ADDENDUM #4 - CM CLARIFICATIONS

Hunger Solution Center
Additions & Renovations
August 21, 2025

ADDENDUM NO. 4
Date: August 20, 2025
TSSF Project # 2154

SHEET NO.
A1.0

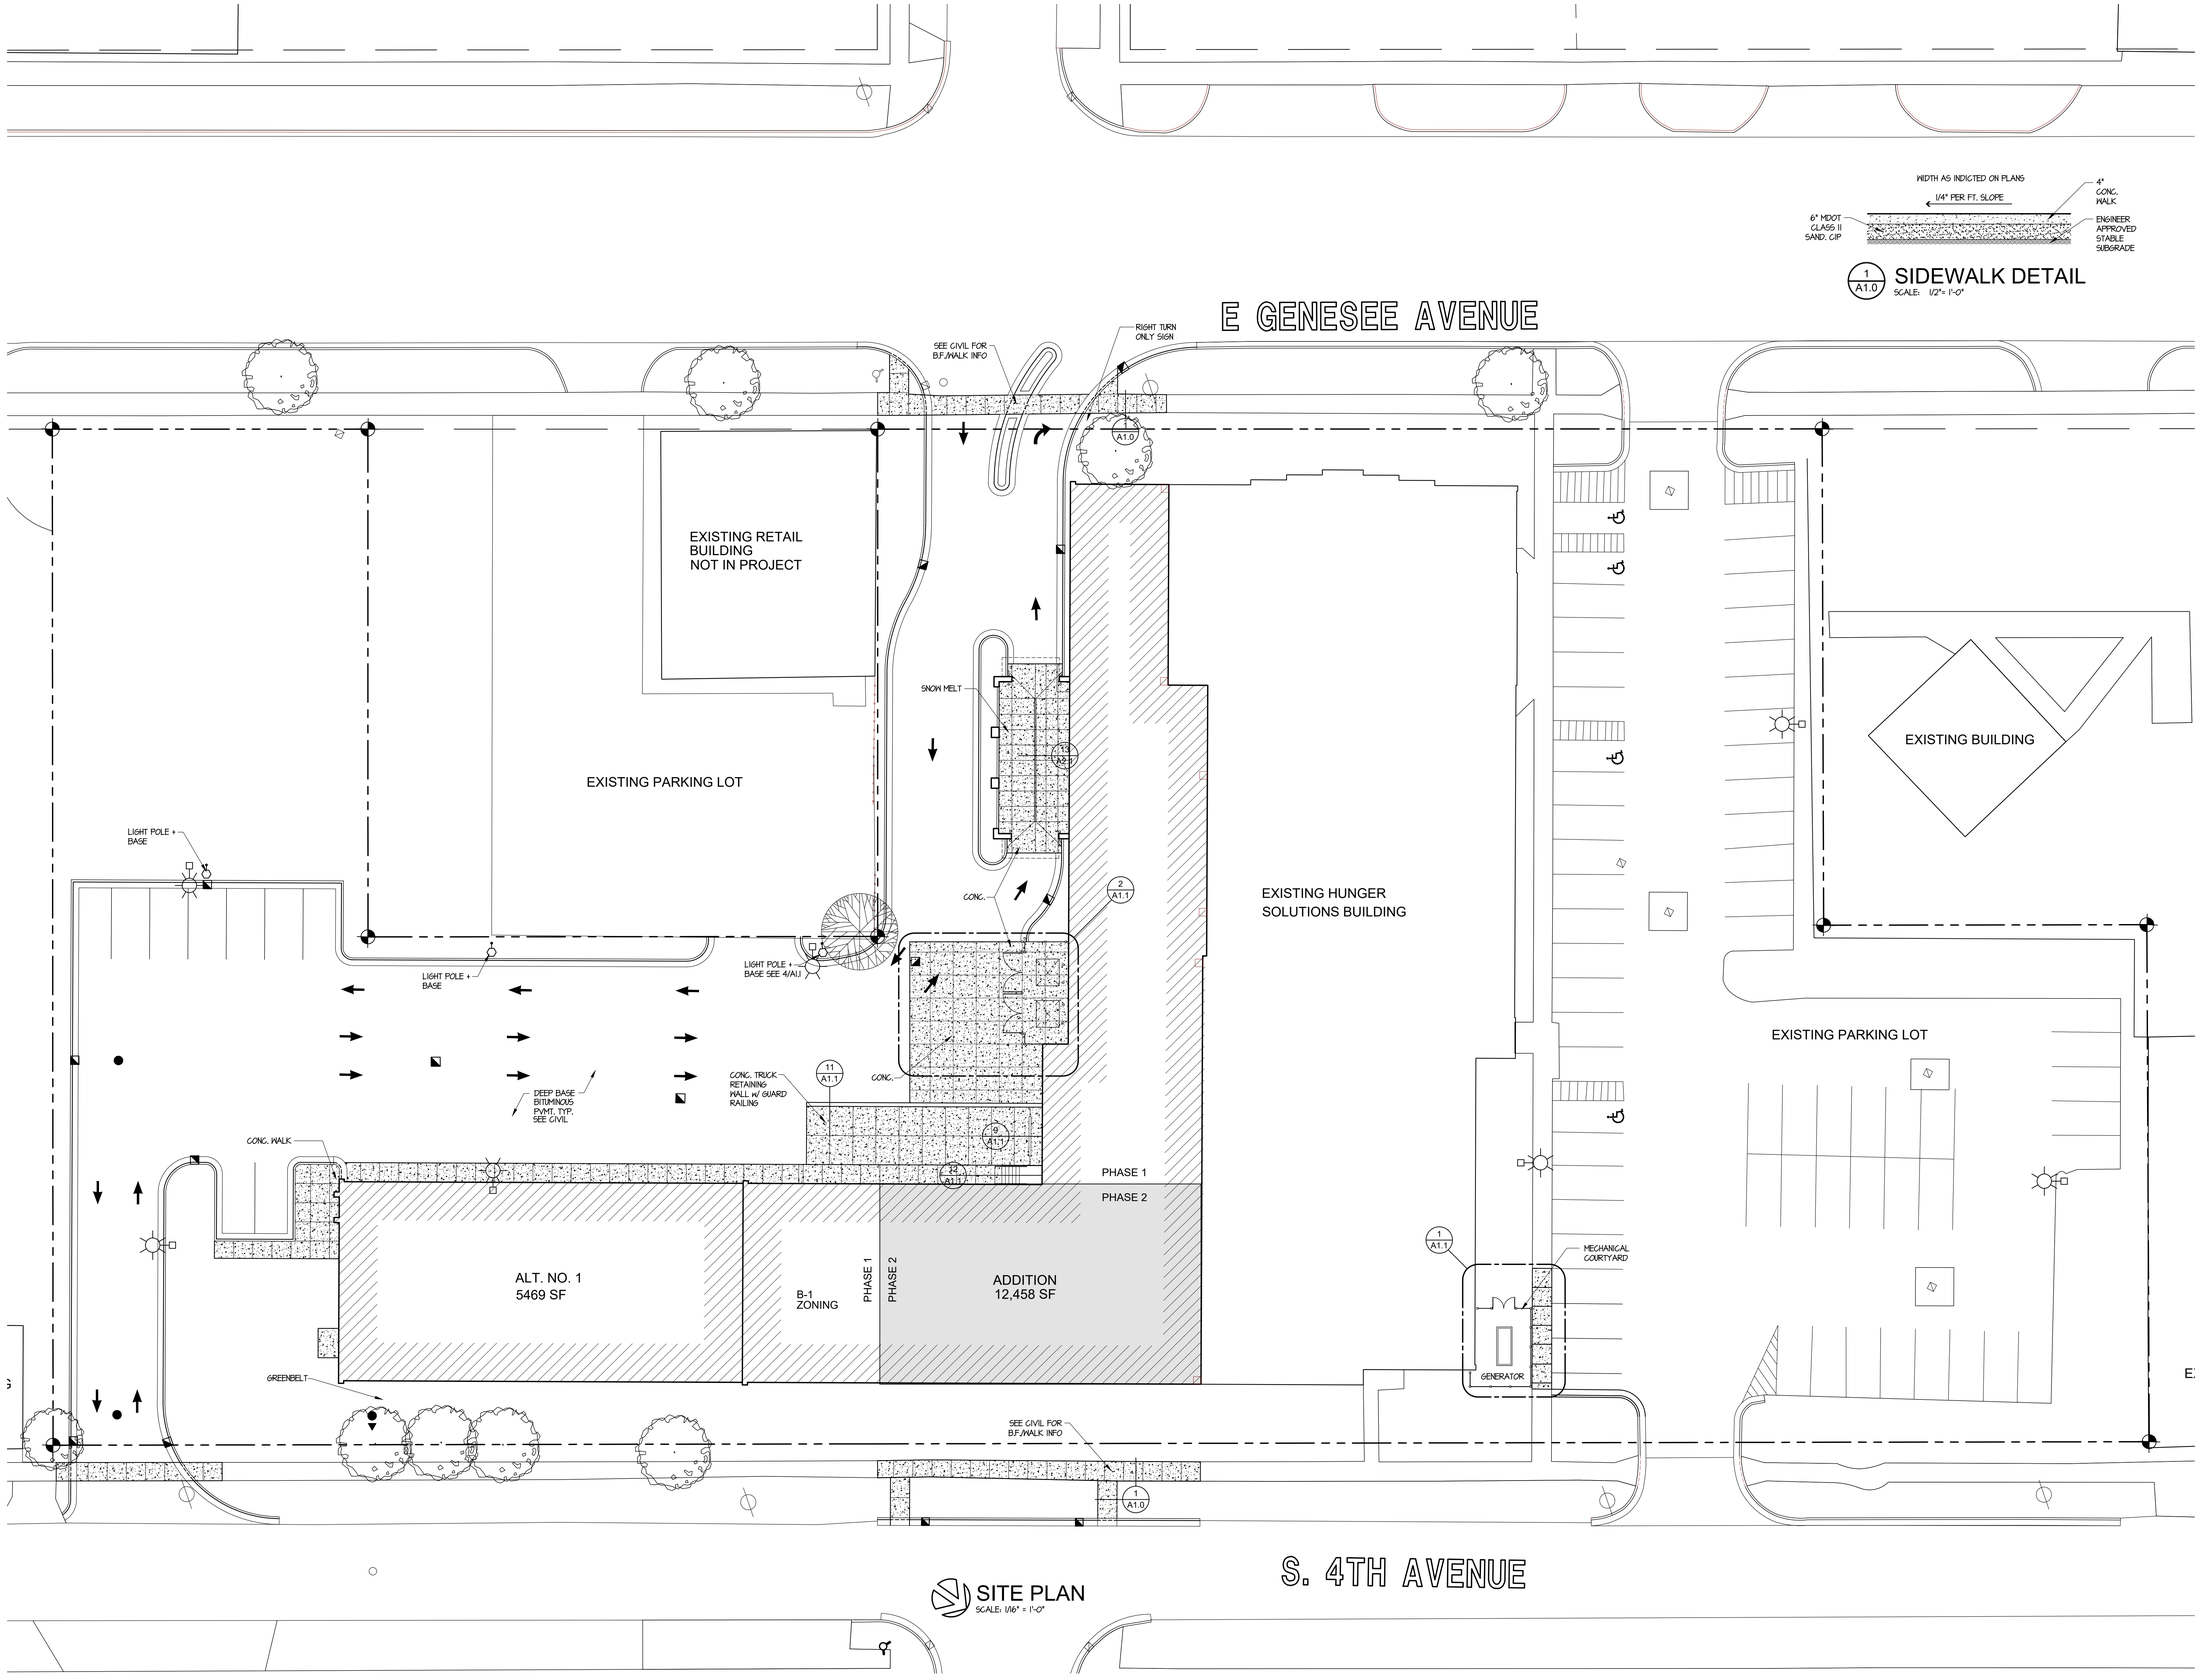
Item A7 **Sheet A1.0: Reissued:**
The Construction Phasing has been indicated on this sheet.

SHEET NO.
A2.0

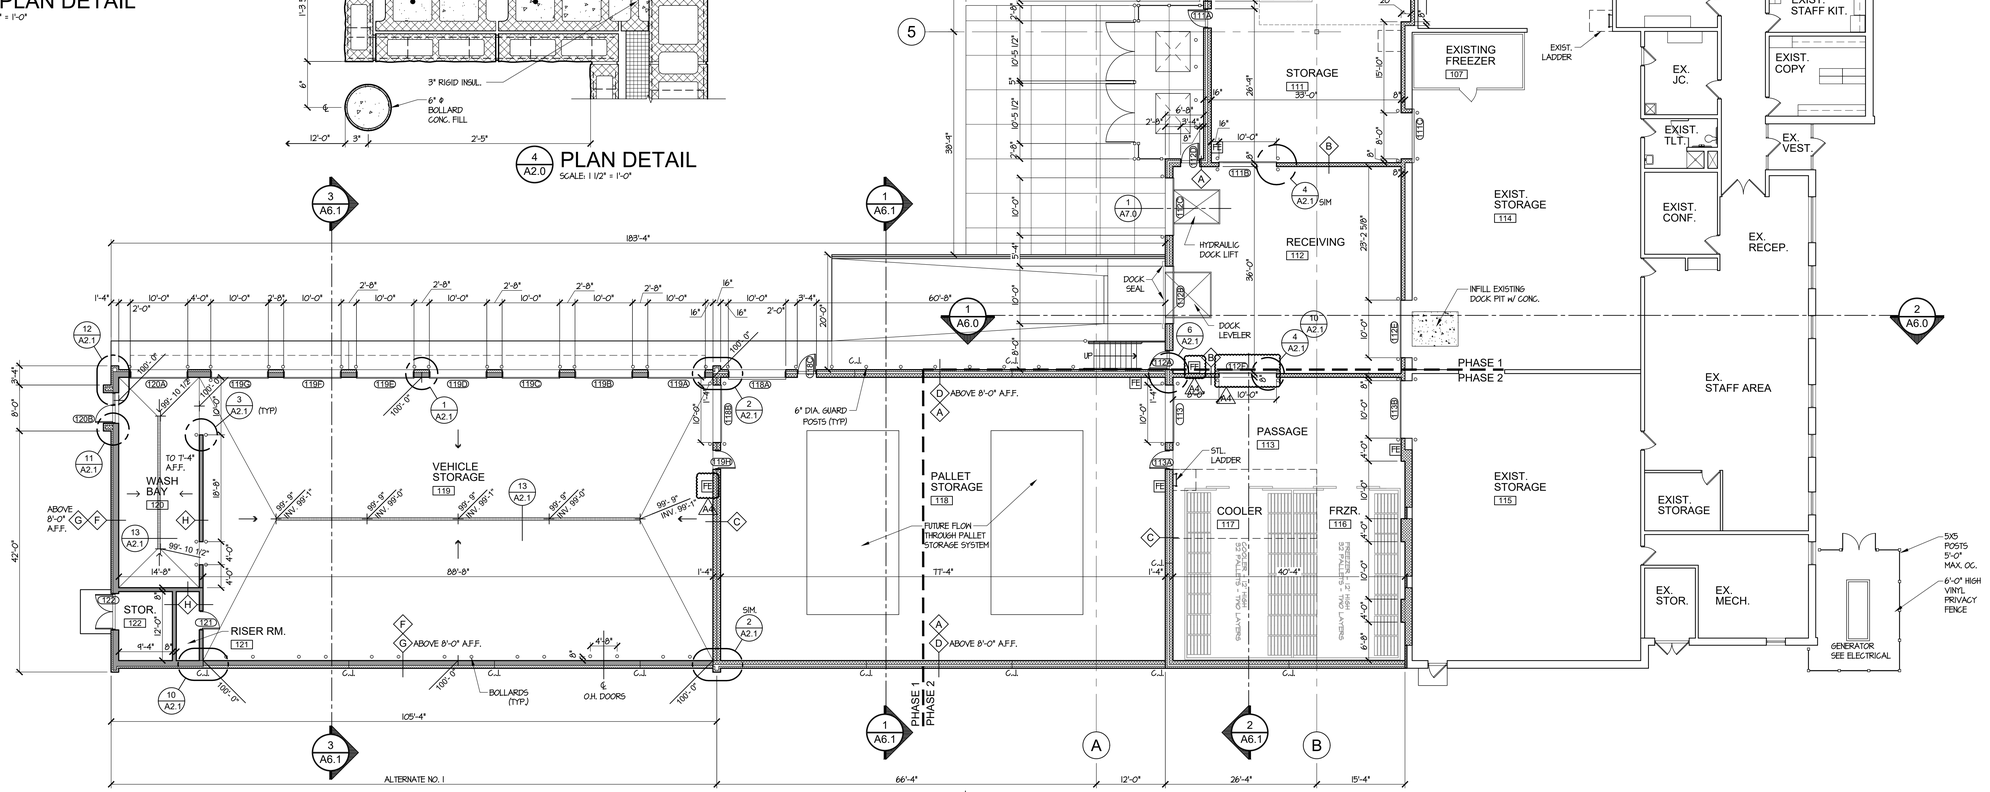
1. On the floorplan on Sheet A2.0, the new passthrough from Dining to Dishwashing does not have a door number on it. I believe this is supposed to be labeled A101A when cross referencing the Door Schedule.

3. On the floorplan on Sheet A2.0, I believe that the opening number for the door between Receiving 112 and Passage 113 is mislabeled. It is currently marked as 112, but I believe that this should be 112F when cross referencing the Door Schedule.

7. Should there be FE's in Receiving 112 and Vehicle Storage 119? None are currently shown in these rooms.

Item A4: **Sheet A2.0: Reissued:**
This sheet is being reissued.
Fire Extinguishers have been added in the Vehicle Storage #119 and Receiving #112.
Door 101A Added at pass through from Existing Dining to Dishwashing.
Door 112F number added in lieu of 112.
Clarification between this sheet and Structural that there is only Alternate #1 as indicated on the Architectural sheet.
Clarification if Alternate #1 is accepted an interior wall on the east masonry exterior wall Needs to be constructed floor to ceiling and shall be 2x4 non comb or metal studs with impact Resistant gypsum board, fiberglass reinforced panels and spray foam insulation. Also, the Under slab rigid insulation will need to be installed 24 inches horizontally and vertically.
Clarification on the construction phasing that phase one of the project is all areas towards Genessee Street from the new truck dock including the adjacent wall and east of the Thompson Street vacation. The intent is to allow access for the owner to continue using the loading doors along the portion of Thompson Street towards Fourth Street. Phase Two is from the new loading dock and wall towards Fourth Street.

15 A2.1 DEPRESSED SLAB DETAIL
SCALE: 1 1/2" = 1'-0"

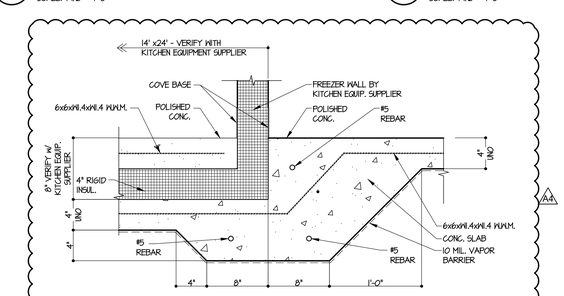
8. See Depressed Slab Detail 15 on A2.1 - is there Quarry Tile on this project? Finish Schedule calls for Polished Concrete. Please revise this detail and / or clarify. NO QUARRY TILE.

Item A5: **Sheet A2.1Detail 15/A2.1: Reissued:**
Detail 15 has been revised to delete mud set quarry tile.

DRAWN BY C.M.B.
DATE 07/03/25
APPROVED
SHEET NO. A3.0
PROJECT NO. 2154

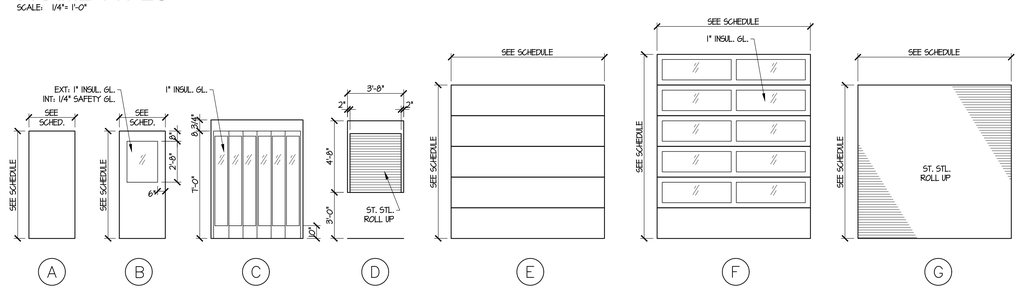
4. Opening 113 on the Door Schedule has this labeled as Door Type 'E', but the remark 5 on this line calls it out as a Coiling Door. Shouldn't this opening be labeled as Door Type 'G'?

5. Opening 120A on the Door Schedule has no label for Door Type. Shouldn't this be Door Type 'F' to match the other adjacent doors along this elevation of the addition?

6. What does T. Hold mean on the sill column of the Door Schedule? My first thought was Threshold, but I have never seen a threshold for an overhead door (reference opening 118A on the current schedule).

Item A6: **Sheet A3.0: Reissued:**
Added door opening 101A coiling counter door.
Door 113 shall be type G in lieu of E.
Door 120A shall be type F.
Door 118A deletes T-hold.

SHEET NO.
A6.0

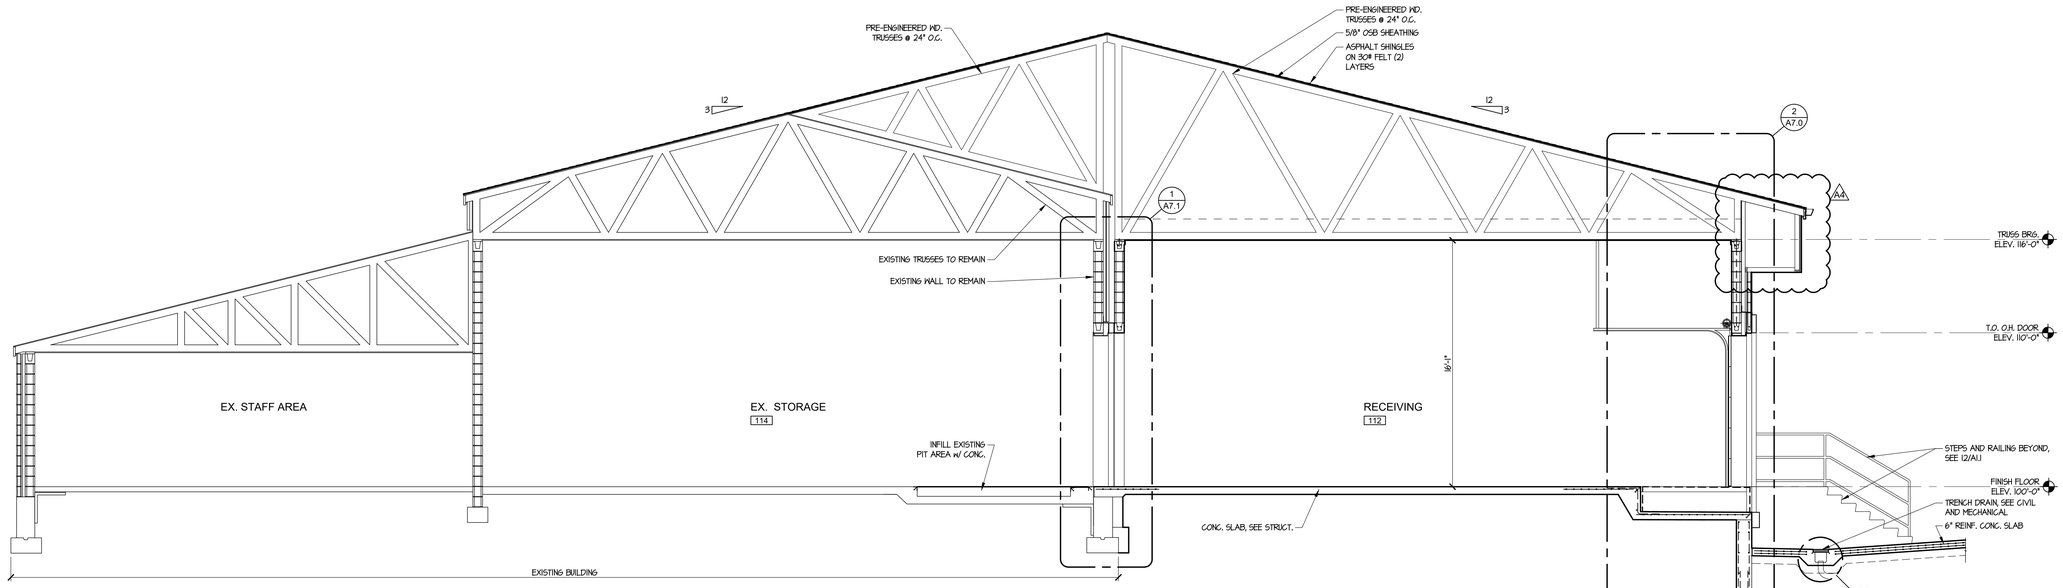
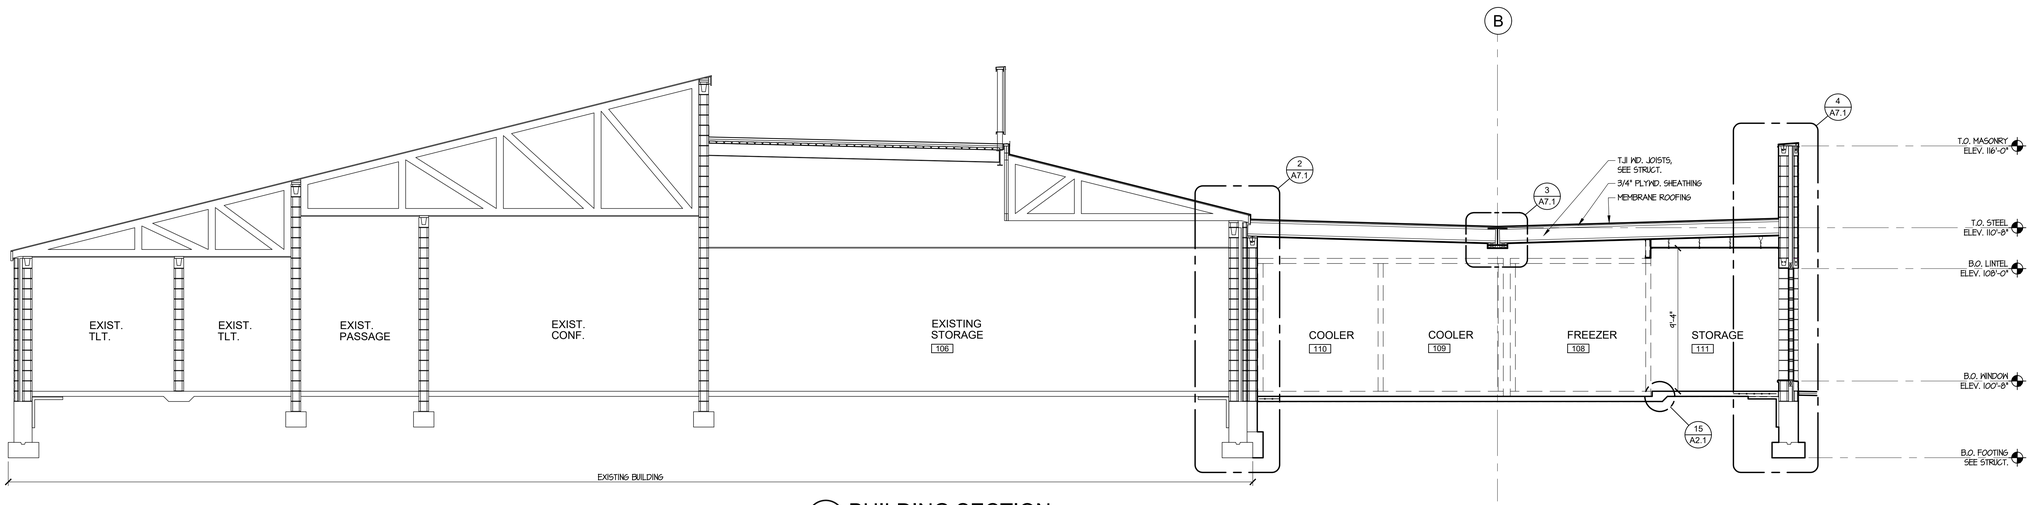
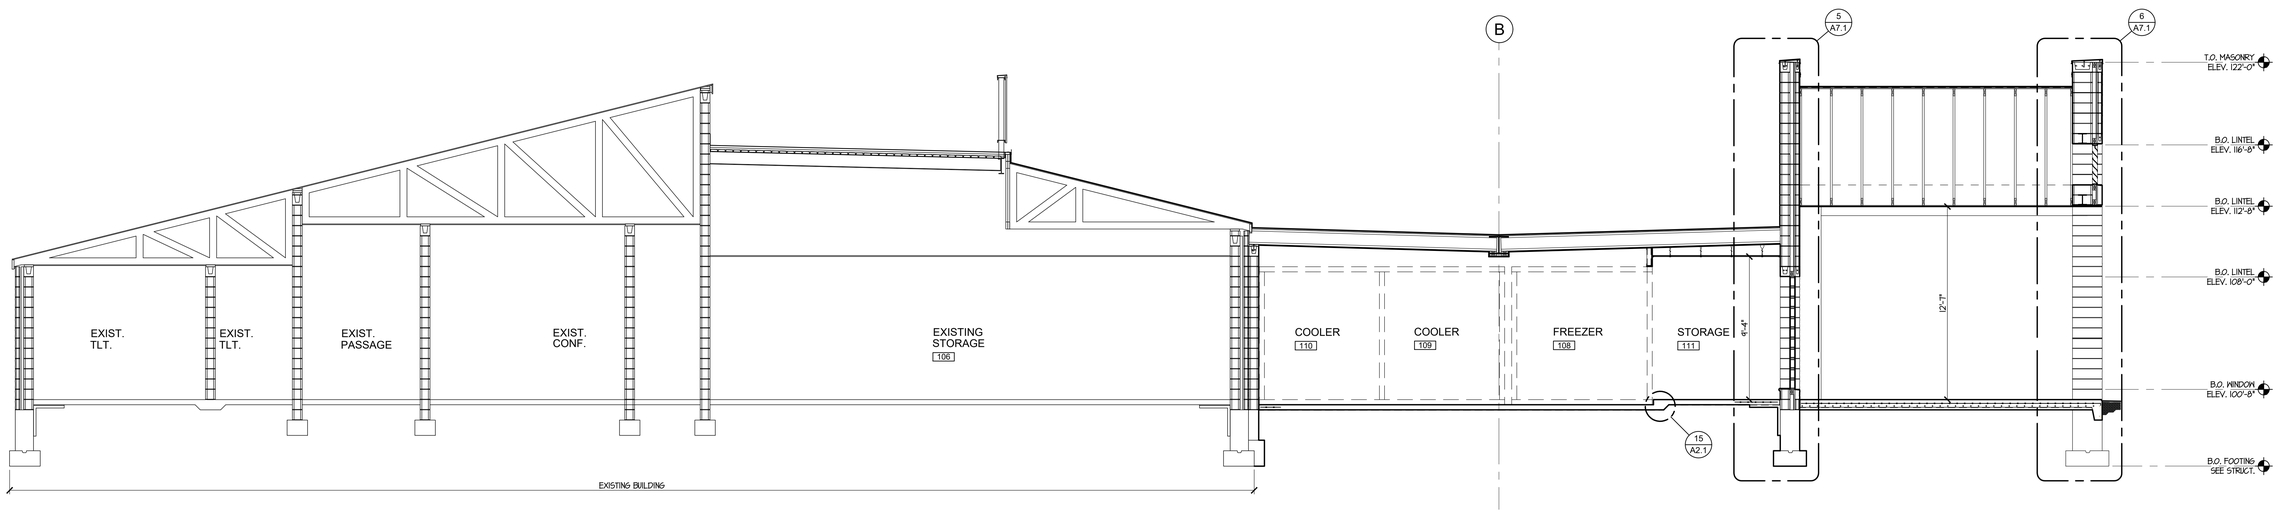
Item A8: **SheetA6.0, Sheet A7.0: Reissued:**
Section 1/A6.0 and 2/A7.0 have been revised to indicate the roof overhang and masonry above the overhead door.
